Revision G This document supersedes previous revisions.
 Addition of a new operation to be performed. The AFSS extinguisher bottle support must be removed and replaced with new reinforced support #406708.

AFSS UPDATE - LTD REPLACEMENT AND RELOCATION OF IR SENSOR Prevost vehicles

On the vehicles affected by this bulletin, replace and relocate the LTD. Remove the existing IR sensor and install an updated IR sensor. Finally, remove and replace the extinguisher bottle support.

FIGURE 9

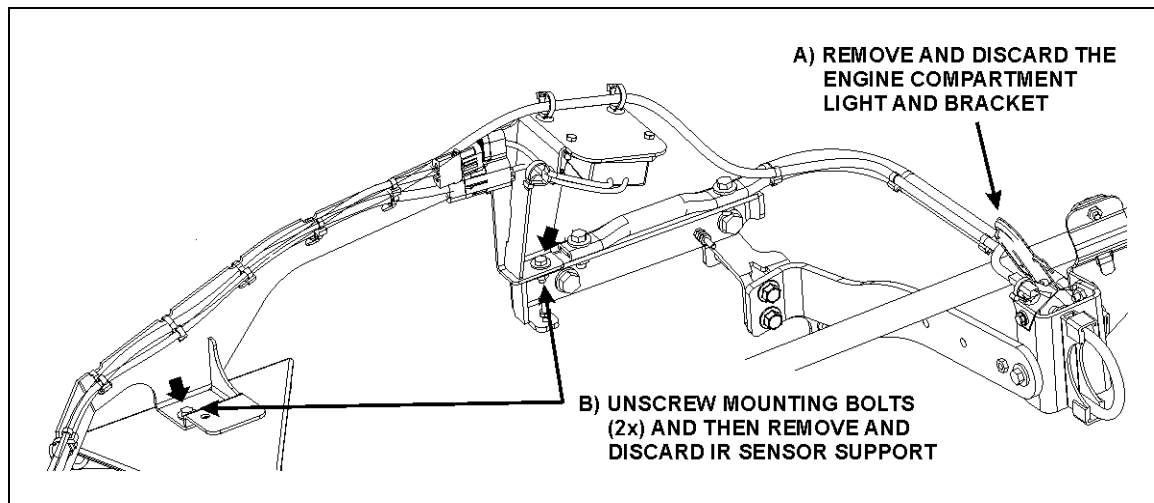
- 10) Remove the bolts from the engine compartment light and bracket (see figure 9, step A).
- 11) Remove the bolts from the IR sensor support (see figure 9, step B).
- 12) Starting from the IR sensor support, cut all nylon cable ties securing the LTD (cable with red sheath). On the engine **hot side**, the LTD is routed under the starter and forms a loop and then comes back and runs to the cold side of the engine (figure 10). On the **cold side**, the LTD is routed as shown on figure 11. Keep the end of line device (EOL) found at the end of the LTD for reused.

FIGURE 16

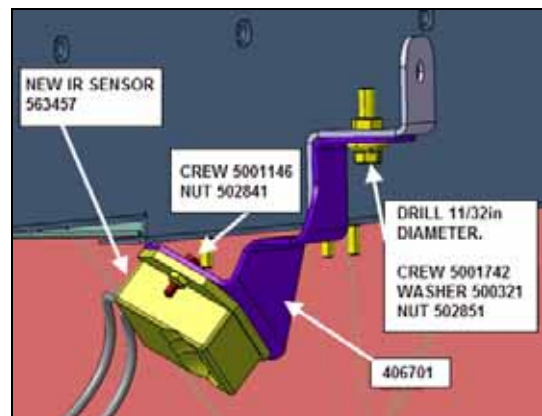
- 17) Unscrew the bolt at the turbo inlet pipe support bracket (figure 15).
- 18) Mount the new IR sensor #563457 onto the new support #406701 (figure 16). Install IR sensor and support assembly onto turbo inlet pipe support bracket as per figure 16.

FIGURE 17

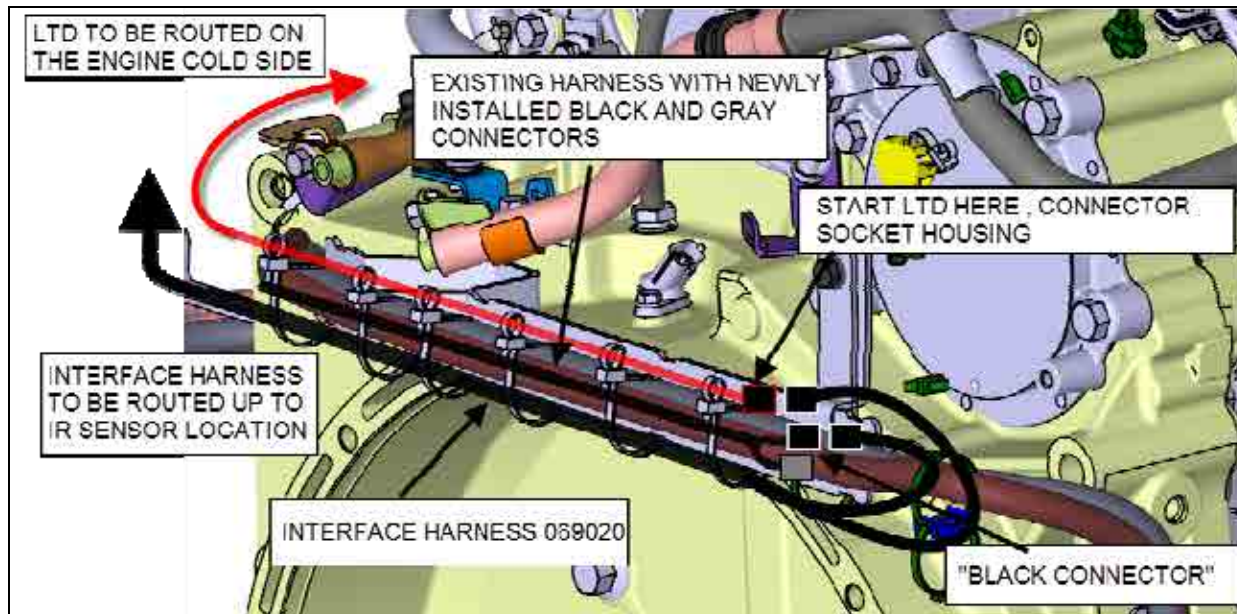
- 19) Secure the interface harness to the surrounding harnesses (see figure 17 for proper installation) using 6 double loop head nylon cable ties 507664. Use the second loop to attach the LTD (figure 17 and 18). Tighten the loop fixing the LTD by hand only. Follow the general recommendations.
- 20) Connect the interface harness as shown on figure 19 and 20.

FIGURE 25

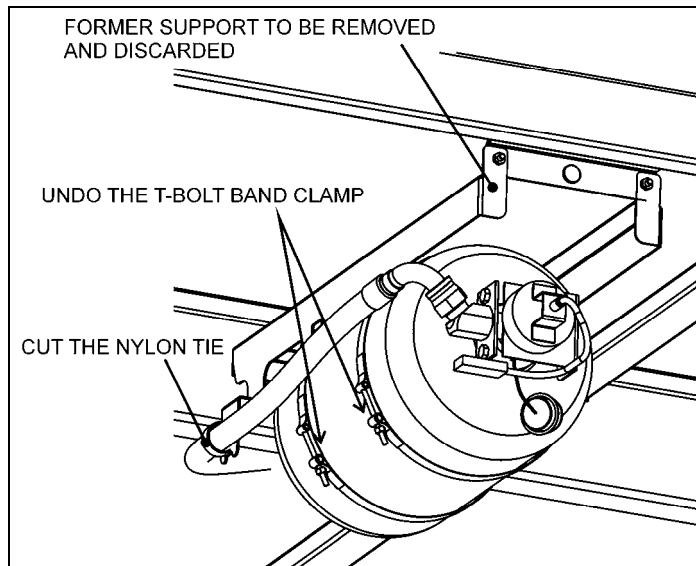
- 27) Open the last L.H. side baggage compartment.
- 28) Place two appropriate jack stands under the extinguisher bottle at about 12 inches from the bottle.
- 29) Cut the nylon tie that fixes the extinguisher bottle hose to the support. **Use caution, the extinguisher bottle weighs 46 lbs.** Undo the two t-bolt band clamps (see figure 25). Rest the extinguisher bottle on the jack stands.

- 30) Remove and discard the existing support.
- 31) Mount the new support #406708 using existing M6 cap screws. Tighten cap screws to **84 lbf-in.**
- 32) Properly install the previously removed t-band clamps to the new support.
- 33) Reinstall the extinguisher bottle to the new support. Tighten t-bolt band clamps nuts to **50 lbf-in.**
- 34) Fix the extinguisher bottle hose to the support using nylon tie #509491.
